UNITED STATES PATENT AND TRADEMARK OFFICE

APPLICATION NO.	FILING DATE	FIRST NAMED INVENTOR	ATTORNEY DOCKET NO.	CONFIRMATION NO.
09/748,281	12/27/2000	Kenneth G. Stewart III	6714/63409	4744

Office Action Summary

DETAILED ACTION

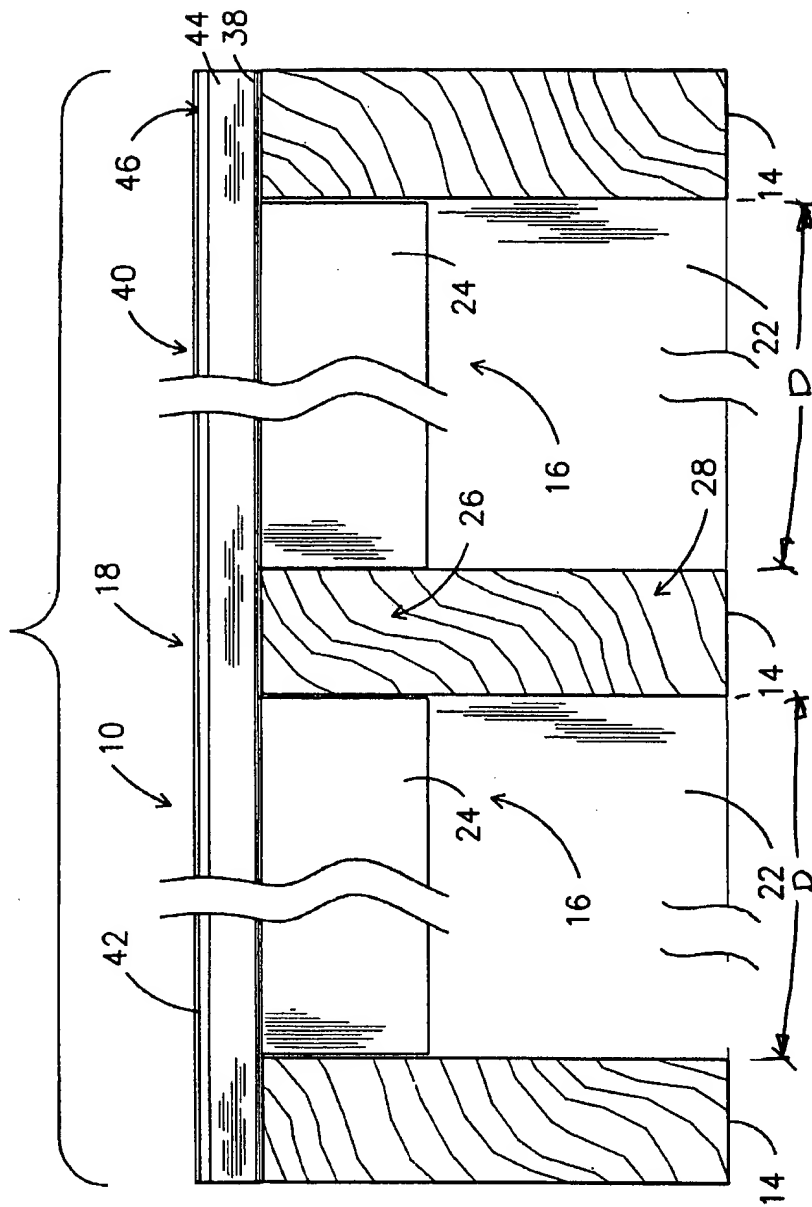
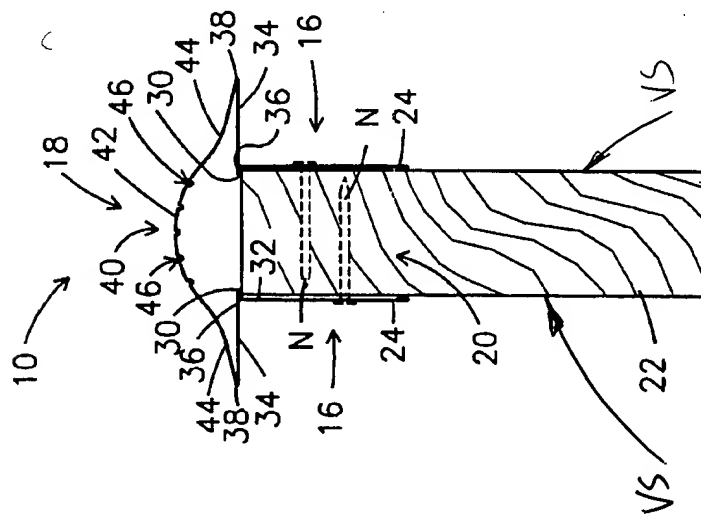
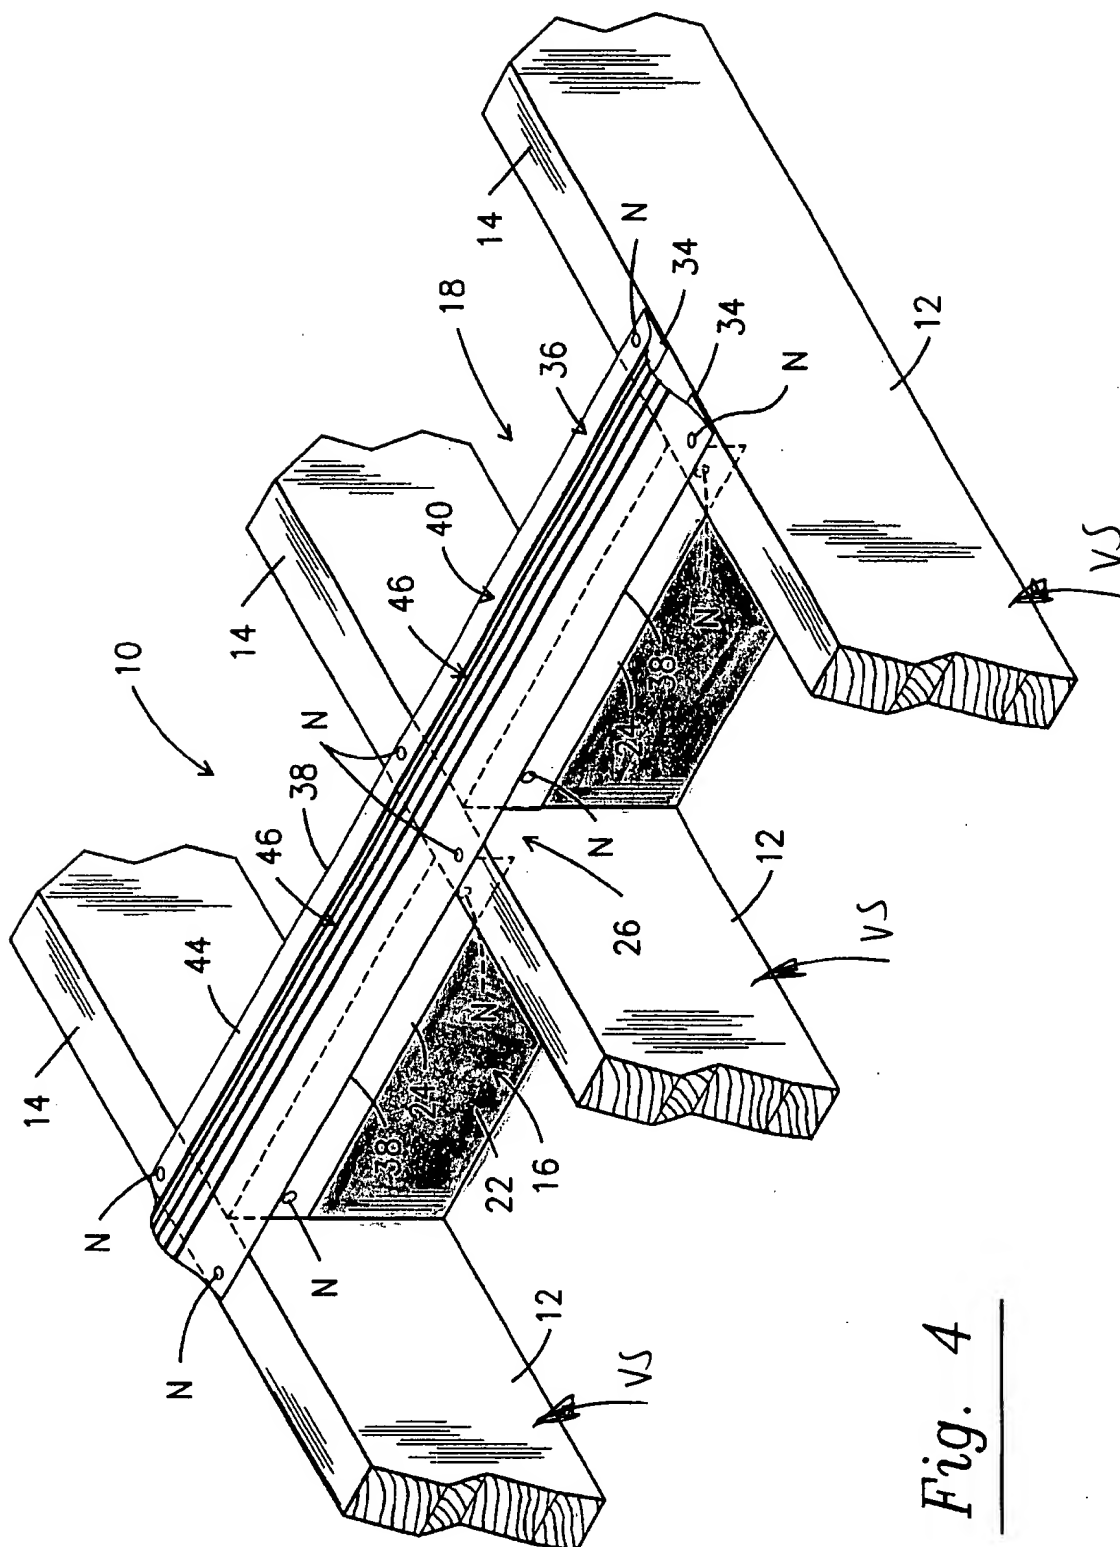
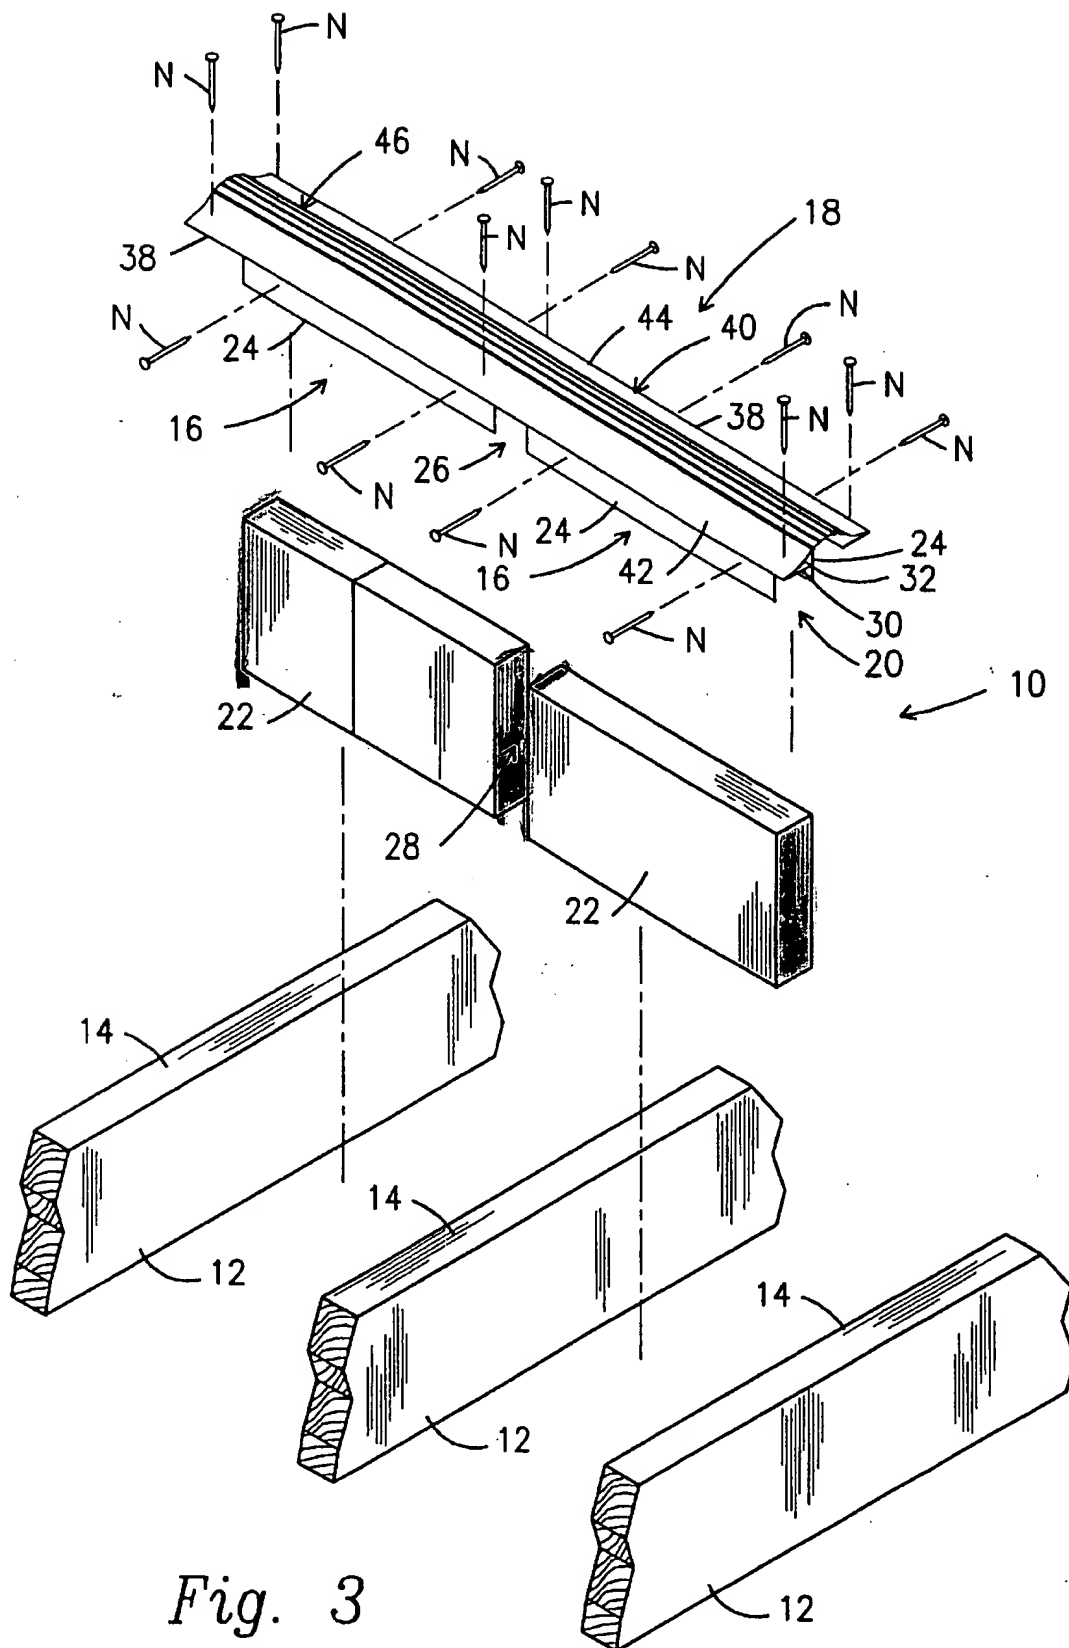
Claim 5 is rejected under 35 U.S.C. 102(b) as being anticipated by US Patent #5,551,200 to KRUG. KRUG discloses the use of a stiffening system (10) for securing adjacent joists (14) including a band (18) that spans three joists (14) and rests upon and is secured to a top surface of the at least three joists (14) as at (30,36), at least two truss members (22) configured as a rectangular box and secured to an underside of the band (18) by an adhesive, column 4, line 25, so as to lie between the joist (14) and with each truss (22) extending between two joists (14) and with the at least two truss members (22) aligned with the band (18). The at least two truss members (22) of the stiffener (18) of KRUG also includes vertical side members (colored red) equal in length

to a spacing (D) between joists (14) wherein the side members (colored red) of each truss (22) abuts the sides (VS) of the joists (14) via the interconnecting stiffener (10) to hold the joists (14) a a specified distance (D), see the marked attachment.
